305 S. CONGRESS PUD

### COMMENT REVIEW REPORT

This report includes all comments received to date concerning your planned unit development. The planned unit development will be approved when all requirements identified in this report have been addressed. However, until this happens, your planned unit development is considered disapproved.

## Setbacks and Land Use Map

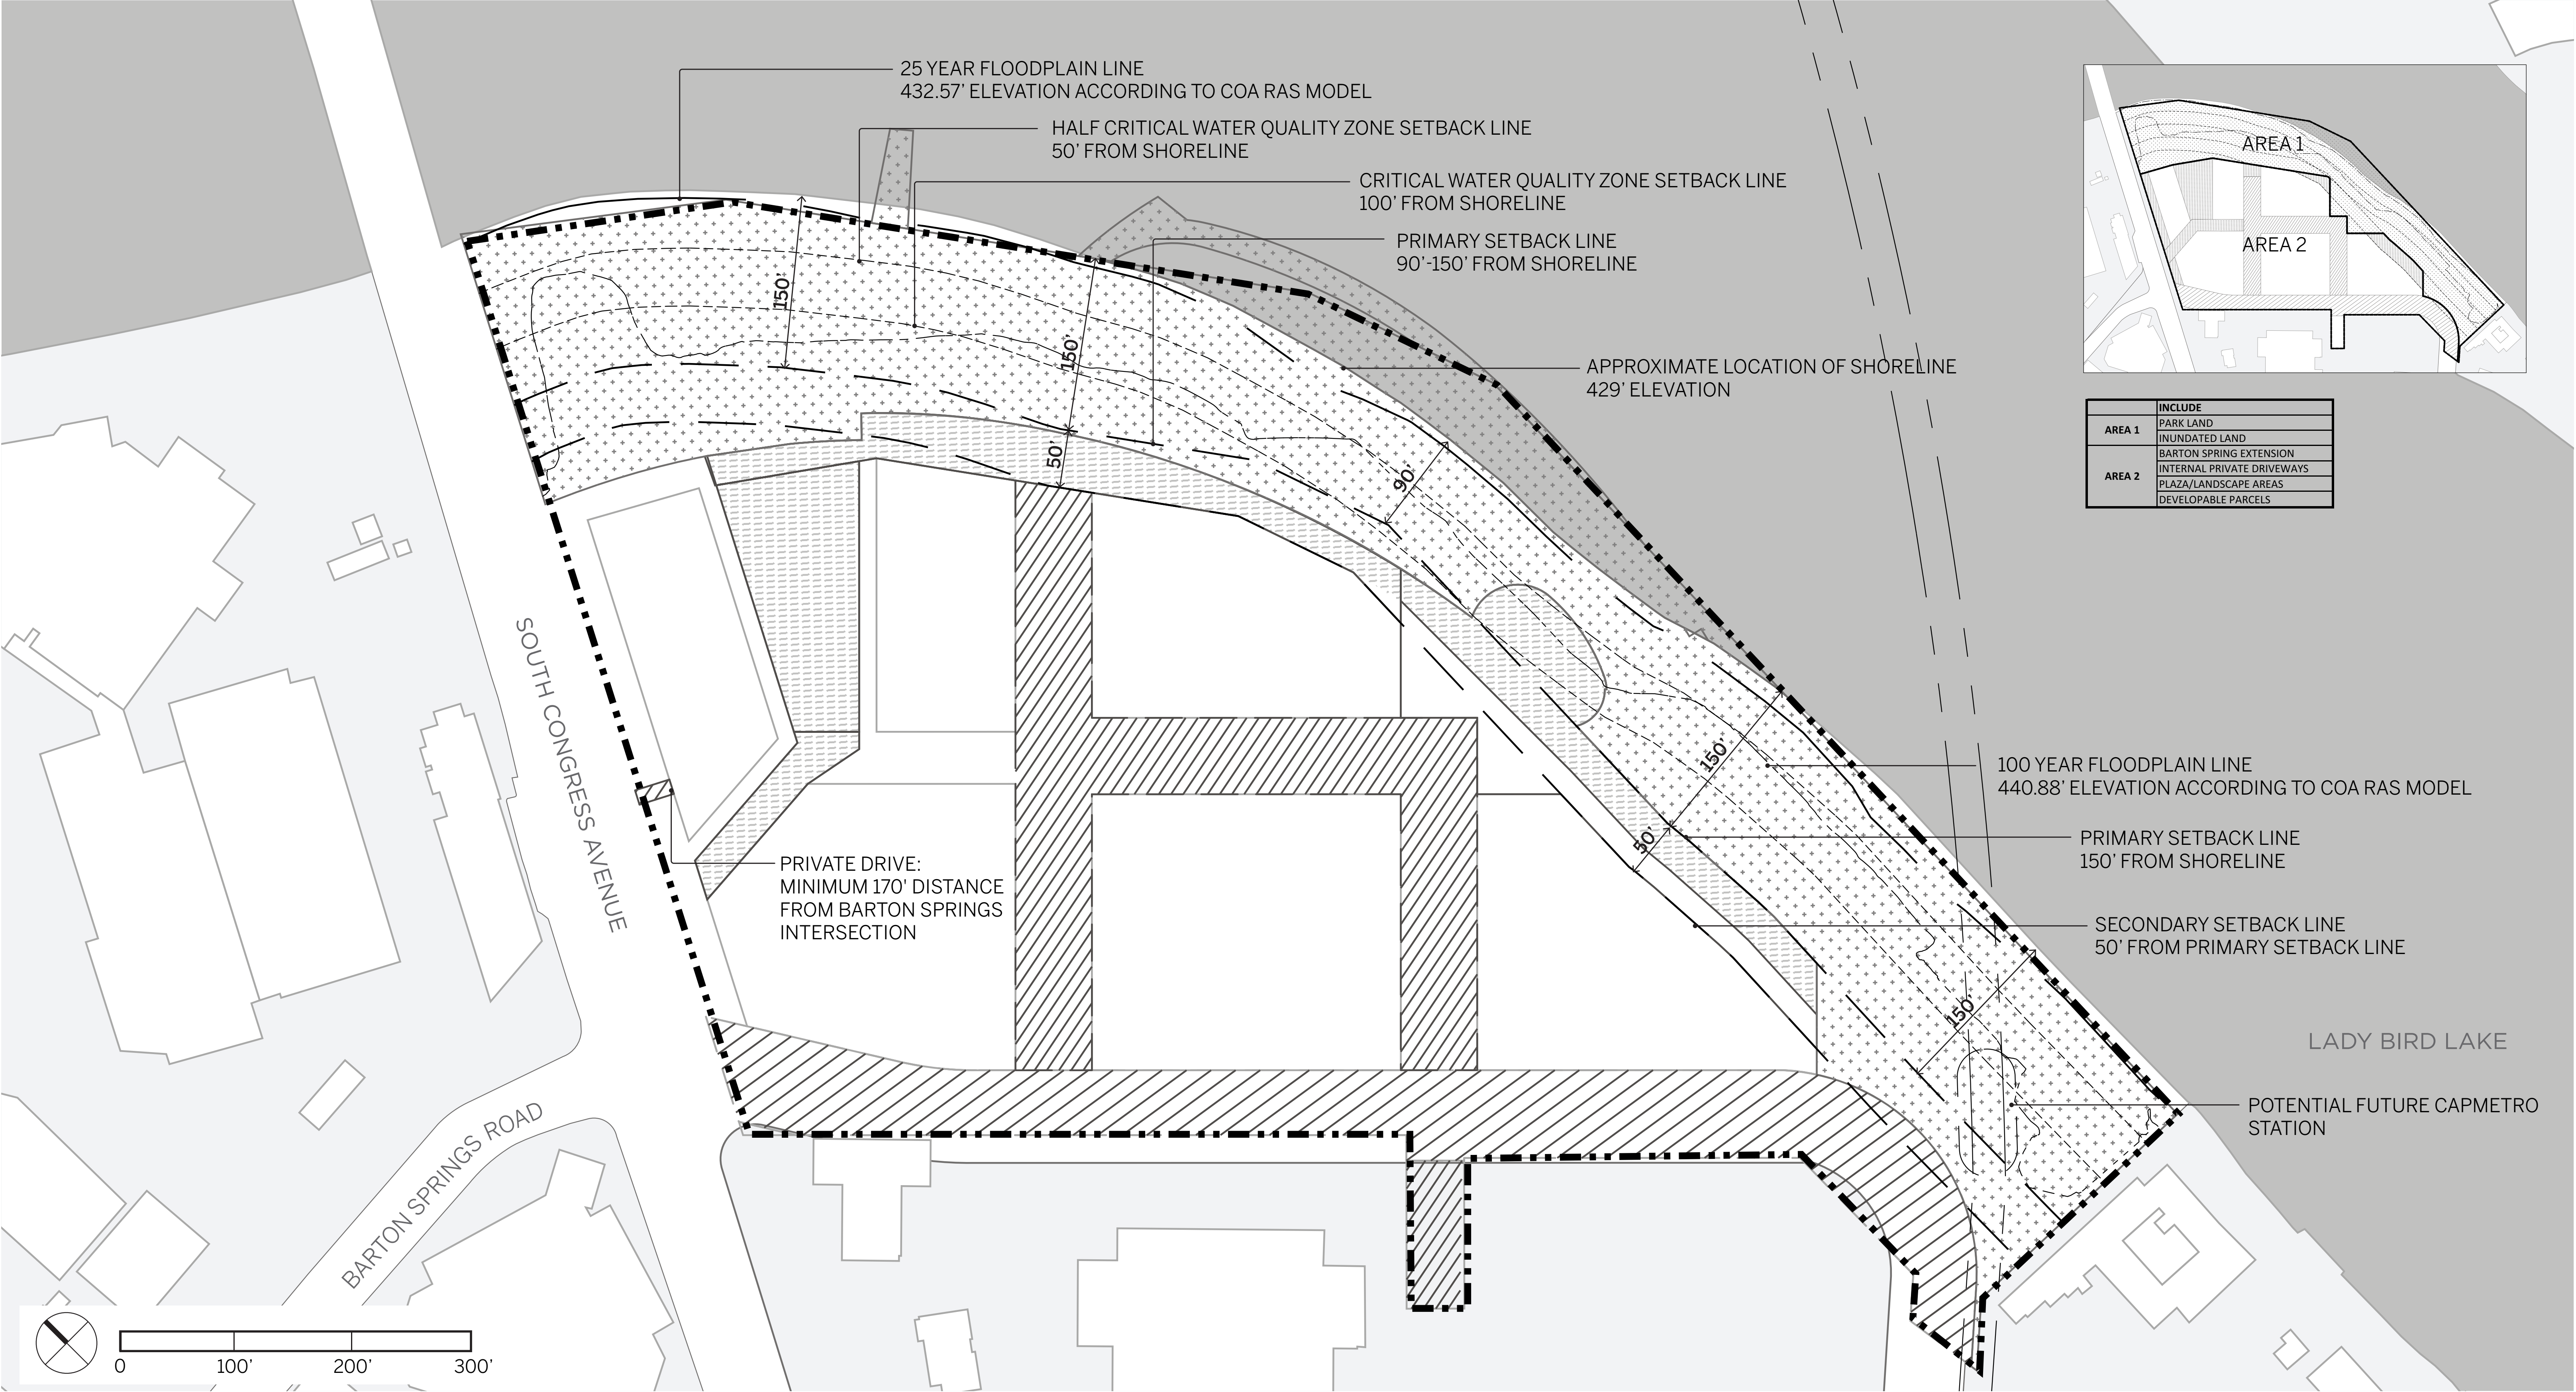
Update 1: Comment pending. Clarification or further division of Pedestrian Oriented Uses is required for Areas 1 and 2. From the *Setbacks and Land Use Map* (Sheet 5) Area 1 is indicated to be the Parkland. It is also mostly encumbered by the Waterfront Overlay Primary and Secondary Setbacks. Staff will not support this extensive of a list for permitted uses within this area. Please provide two separate lists for Pedestrian Oriented Uses for Area 1 and Area 2.

Conceptual Open Space Map

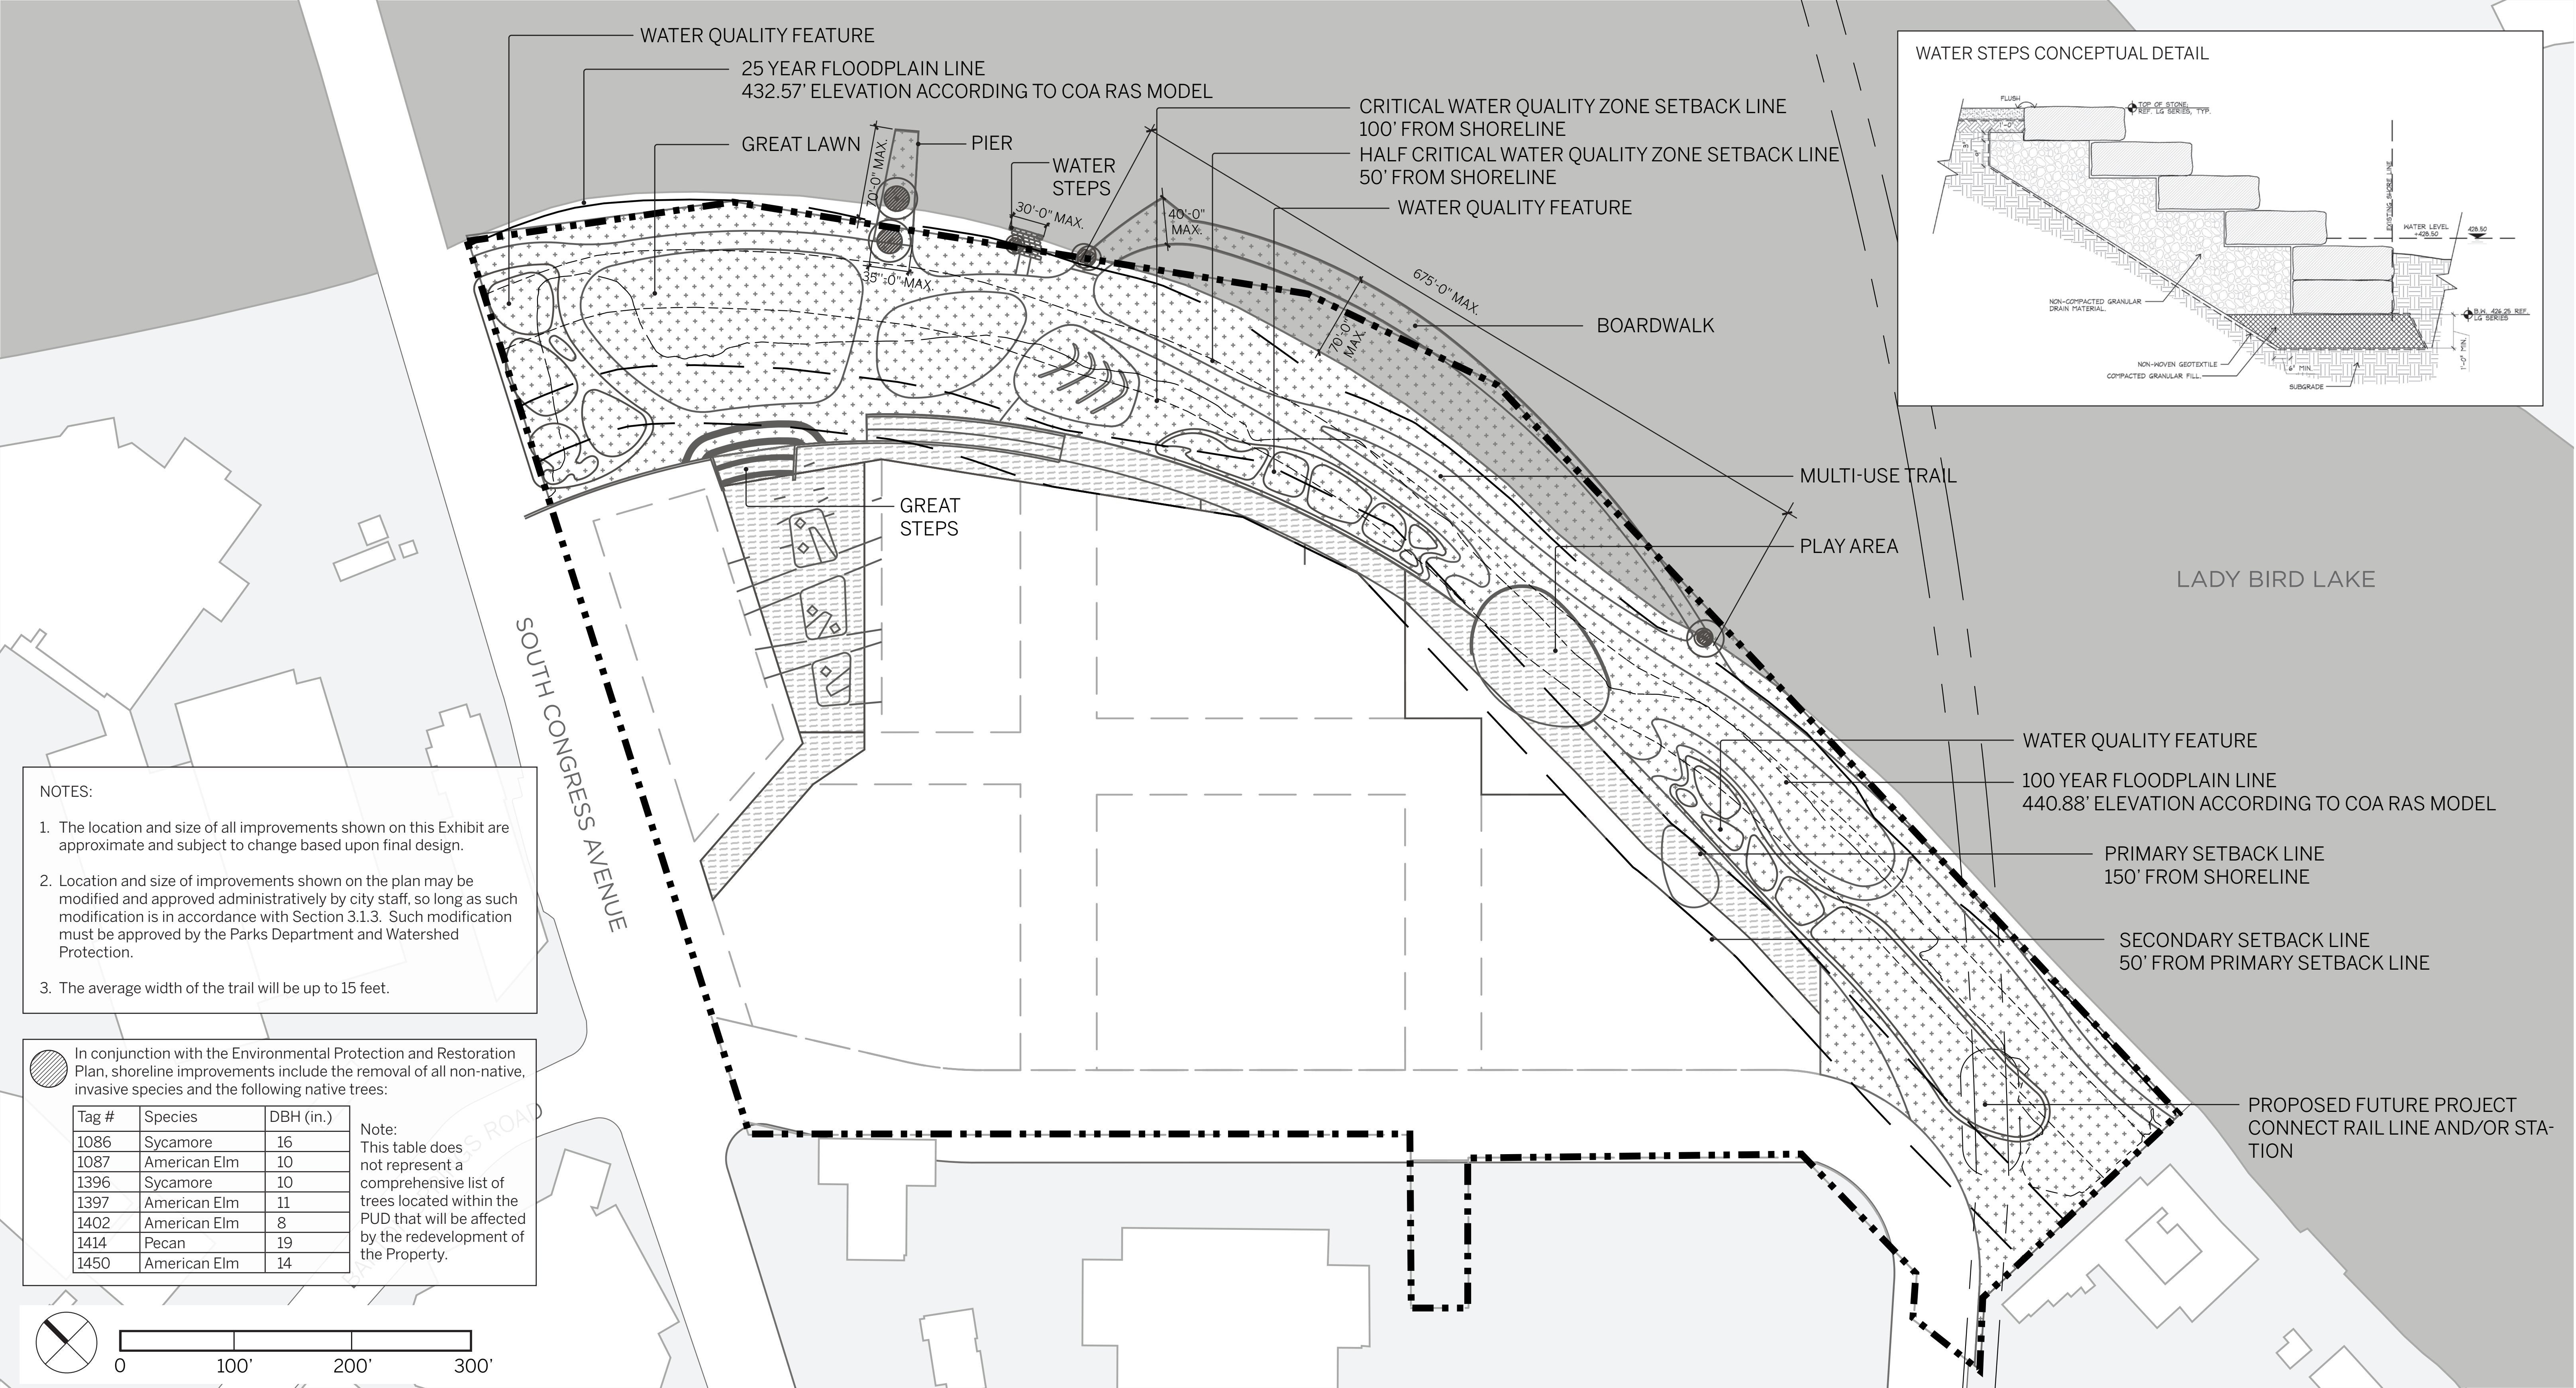
- EO 4. Please provide an exhibit that captures the improvements planned for the Parkland/Open Space. Please contact us to set up a meeting about what would be expected on the exhibit. This sheet will become an exhibit within the PUD document.

Update 1: Comment pending. Open Space exhibit provided does not match the exhibit or intent of the South Central Waterfront overlay plan. Add a note to the Open Space plan that states: "Improvements shown on the plan are conceptual and will be finalized at time of site plan."

- PR 6. Note on Sheet 6 indicates that parkland areas can change based on Cap Metro station. Consider the sequence and how this might be accomplished. The challenge is to dedicate the parkland, and move towards superiority, while allowing some flexibility for the station. Ideally, the park will be designed to dovetail with a future station.

Update 1: Thank you for Open Space Map (Sheet 6). Identify location of pavilions, and any other planned elements not shown on this plan. Since the PUD will unlikely be able to meet the acreage requirements of 10.4 acres per 1,000 residents (see PR4), superiority will need to be made up in design and construction of a superior park system (and the remainder to be made up by fees in lieu of land at time of site plan). See PR 3 regarding park development superiority. Park development shall be consistent with the South Central Waterfront Vision Plan.

Update 1: Please confirm that the Pontoon Landing is the same as “Pier” on Sheet 6.

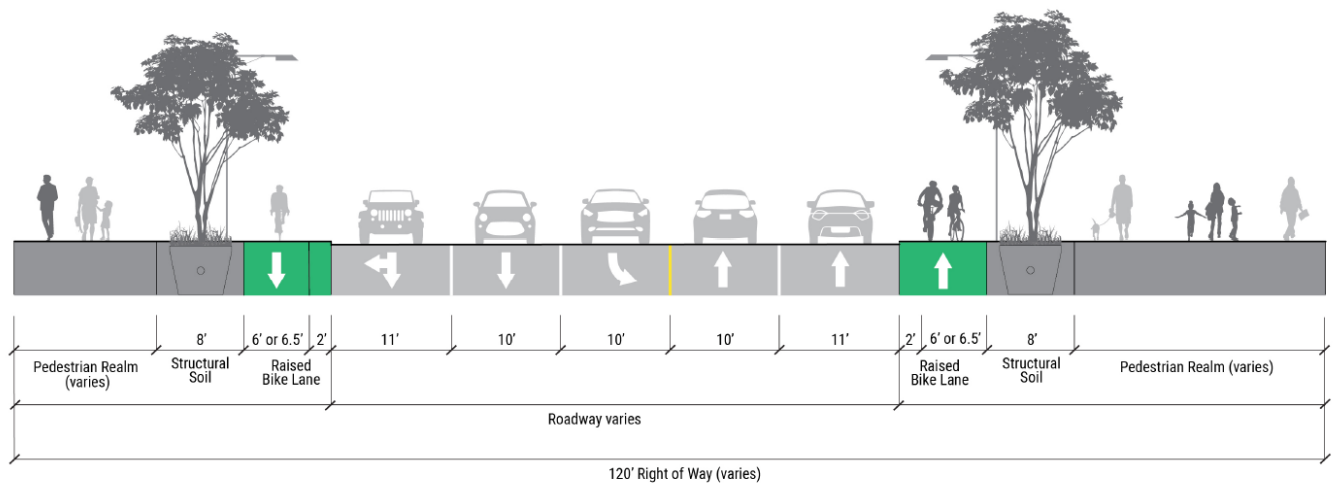
- ATD 5. Street Section A-A: No bike facility is shown in this cross section. The South Central Waterfront plan calls for **a 6'-6.5' raised bike lane behind a 2' buffer** along the east frontage of S. Congress. The ASMP identifies protected bicycle facility along Congress frontage as well. In order to meet the superior results expected from PUDs, the cross sections should at least meet the baseline set by ASMP.

**Update 2: The recently installed protected bike lanes must still be included within the cross section. PUD A-A cross section should mirror South Central Waterfront Plan for S. Congress (Core Transit Corridor):**

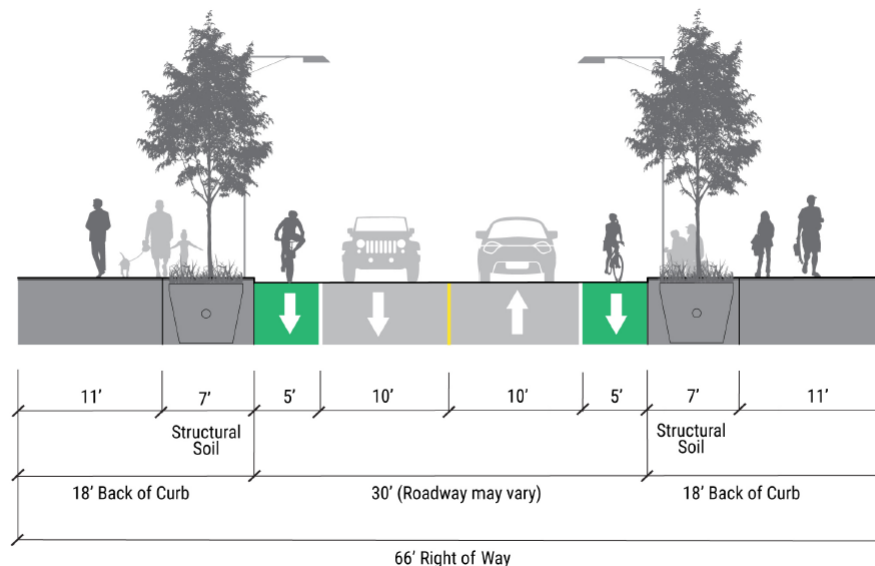
- ATD 6. Street Section C-C: ASMP calls for this to be a 2-lane street with all ages and abilities bike infrastructure. If this is planned to be a street with low volume (less than 3000 ADT), national best practice would make a simple 5' painted bike lane in each direction acceptable for this facility, which would fit within the roadway width indicated in the cross section. If higher vehicular volume is planned, a protected bicycle lane would be necessary to be an all ages and abilities facility.

**Update 2: If 5000+ VTD are anticipated, protected bike lanes are required. The South Central Waterfront Plan requires min. 5' bike lanes (see "Local Street" cross section from SCWP below):**

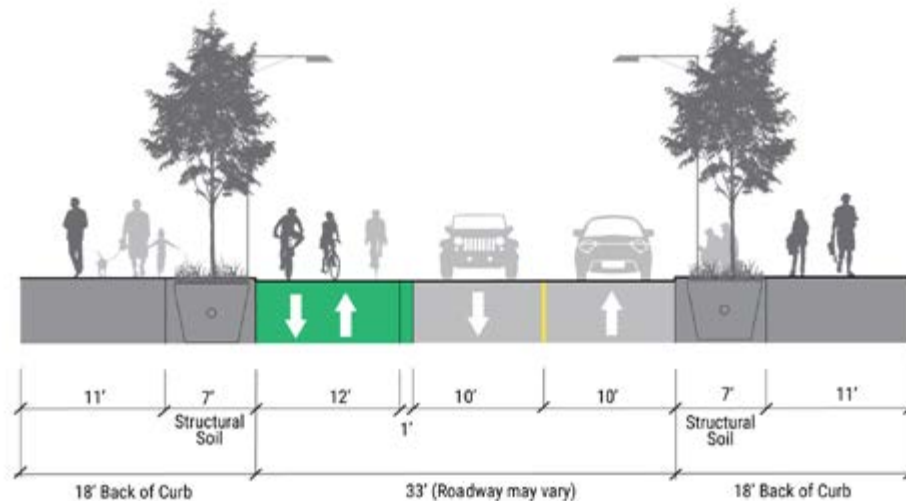
- ATD 7. Street Section D-D: ASMP calls for this to be a 2-lane street with all ages and abilities bike infrastructure. If the space shown in the cross section is intended as a two-way cycle track, it should be shown that way with vertical separation from vehicular travel space. If that is the

case, 10' would be very constrained given the context of a possible future pedestrian bridge. Recommend 12' minimum width plus a barrier.

**Update 2: The SCWP identifies a 12' cycle track with 1' buffer as needed for this shared street. Comment pending further internal review.**

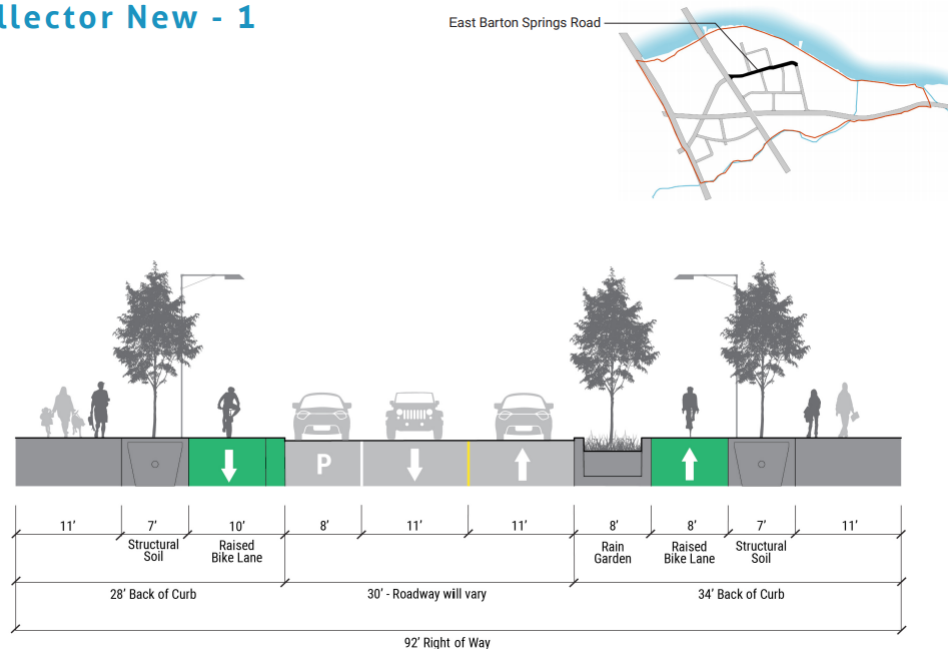
- ATD 10. All new internal roadways, including the extension of Barton Springs Road (requiring 92'), should be publicly dedicated rights-of-way according to the ASMP (detailed in the following chart). Please clarify the following:
- The Barton Springs ROW extension does not meet the ASMP required 92' width or required bike and pedestrian elements of the South Central Waterfront Plan (see below). A "shared lane" is not a bicycle accommodation that ATD approves and separated raised bike lanes are needed.

**Update 2: Comment pending TIA and further internal review. At least the northern streetscape (including the 8' min. raised protected bike lane) must be built; this segment is not contingent upon development to the south of this property.**

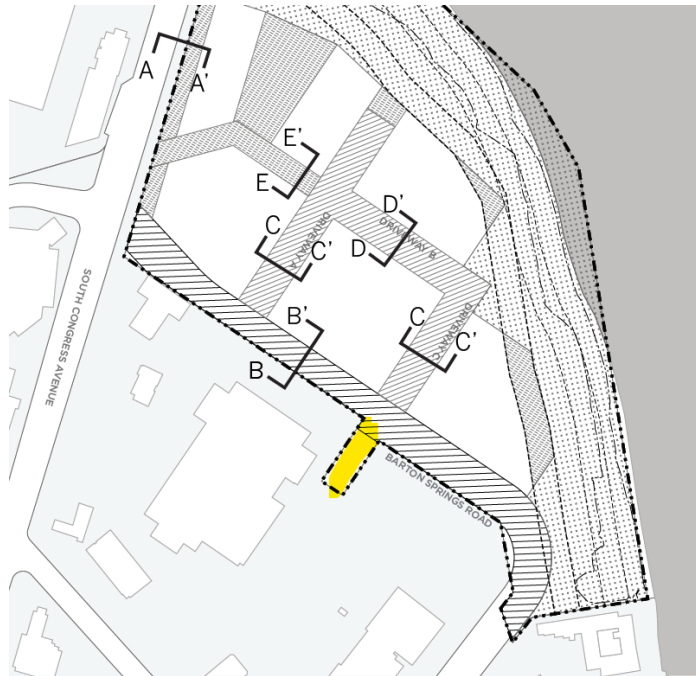
- c. “Driveway C” should extend southward as dedicated right-of-way to allow for future extension, as is required by the ASMP and South Central Waterfront Plan (see relevant highlighted segment below).

**Update 2: Comment cleared. Urban Design has indicated that this segment is intended to be dedicated as parkland (“Crockett Square”), per the South Central Waterfront Plan.**
